SERVICE BULLETIN

120

TITLE
INSPECTION OF RUDDER BAR SUPPORT BRACKETS
CLASSIFICATION

T67B, T67C Series, T67M (Works No.1999 Not applicable), T67M-MkII, T67M200, T67M260 and T67M260-T3A.

FIG 1
RUDDER PEDAL MECHANISM

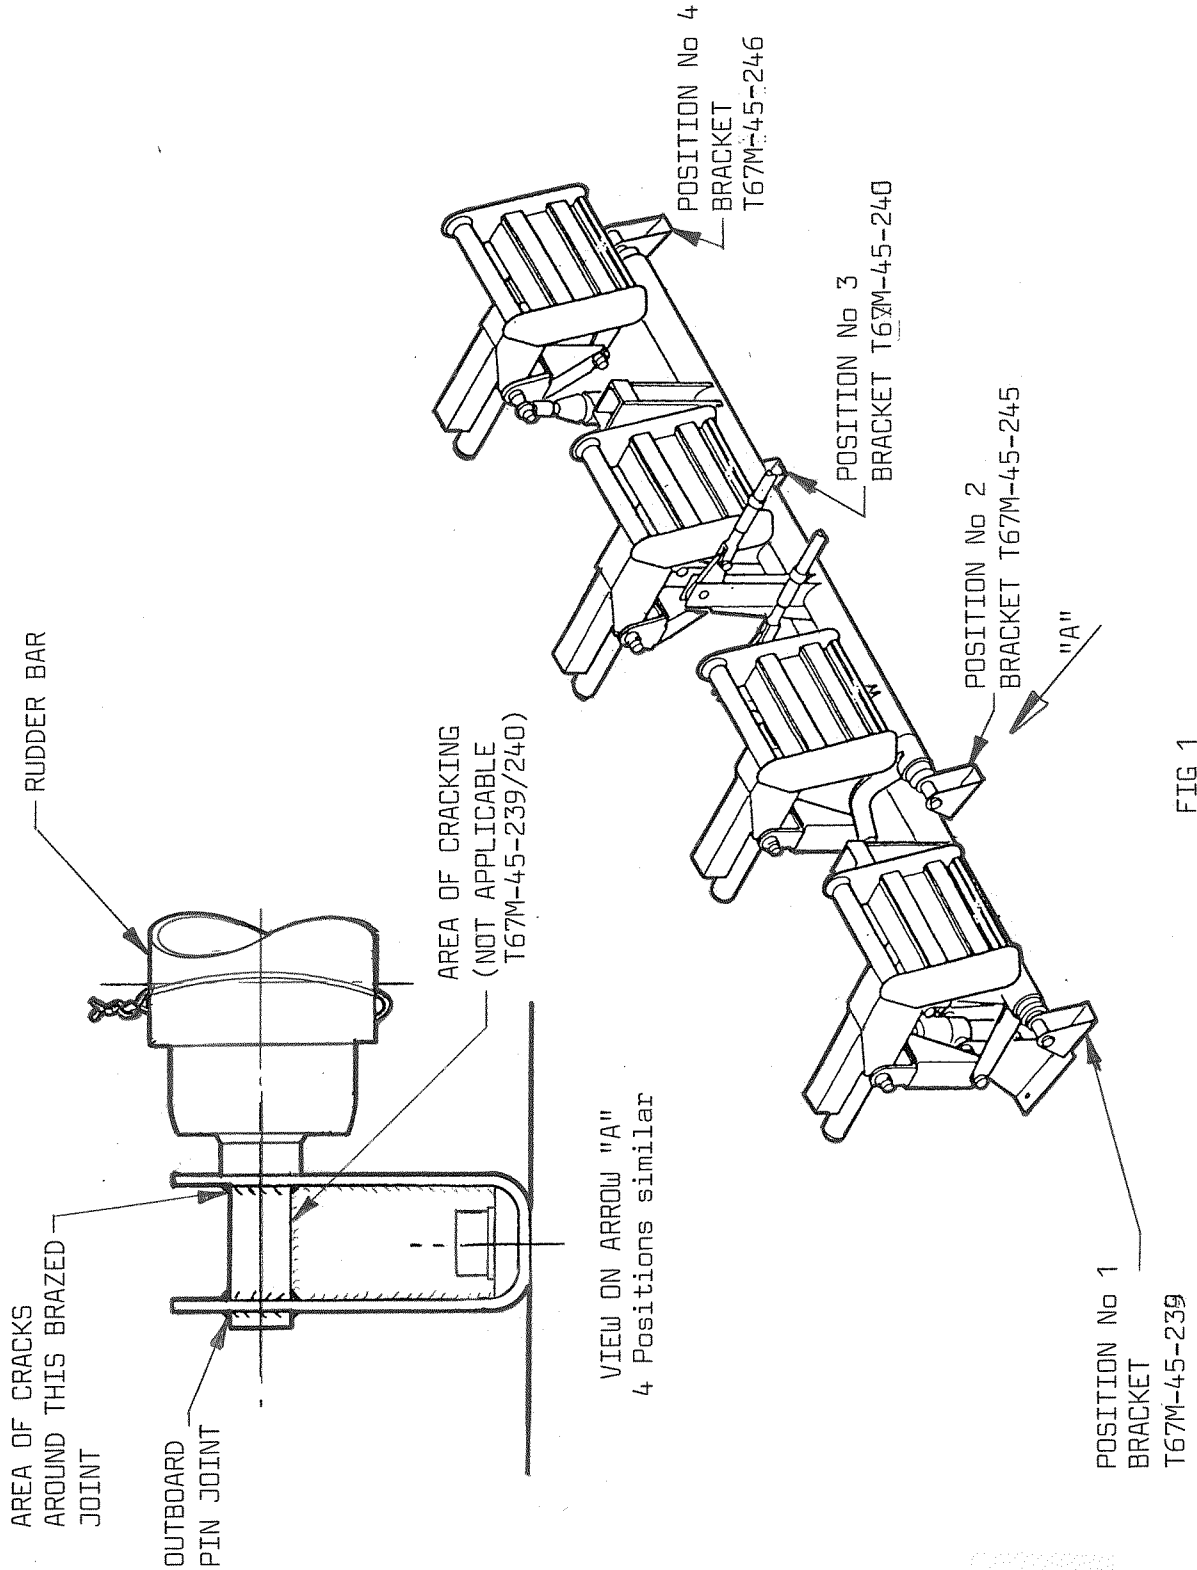
Cases have been reported of cracking in the following brazed joints on the rudder pedal bar support bracket T67M-45-245: inboard pin joint and web to pin joint.

1. Gain access to rudder bar support brackets, ref. Fig. 1.
 - 1.1 Establish whether the brackets are brazed or welded. Welded items should have prominent fillets. If in doubt remove paint from joint. Welded joint will have natural metal colour. Restore finish.

2. Check brazed joints for cracking Ref Fig. 1 View on Arrow A.
 - 2.1 If no cracks are found, annotate logbook SB120 Iss 3 satisfied. Repeat inspection at 150 hour intervals.
 - 2.2 If cracking is found.
 - 2.2.1 Provided web crack is no more than 50% of the joint length, and the outboard joint to the pin is intact, flying is permitted, but bracket is to be replaced within 150 hours.

It is acceptable to have pin inboard joint with a 100% failure and still fly for up to 150 hours.
 - 2.2.2 Should web crack exceed 50% of its joint length and 100% of pin inbd joint cracked, then no further flight is permitted until bracket is repaired or new item fitted.
3. Following inspection rectification 150 hr inspection still to apply.
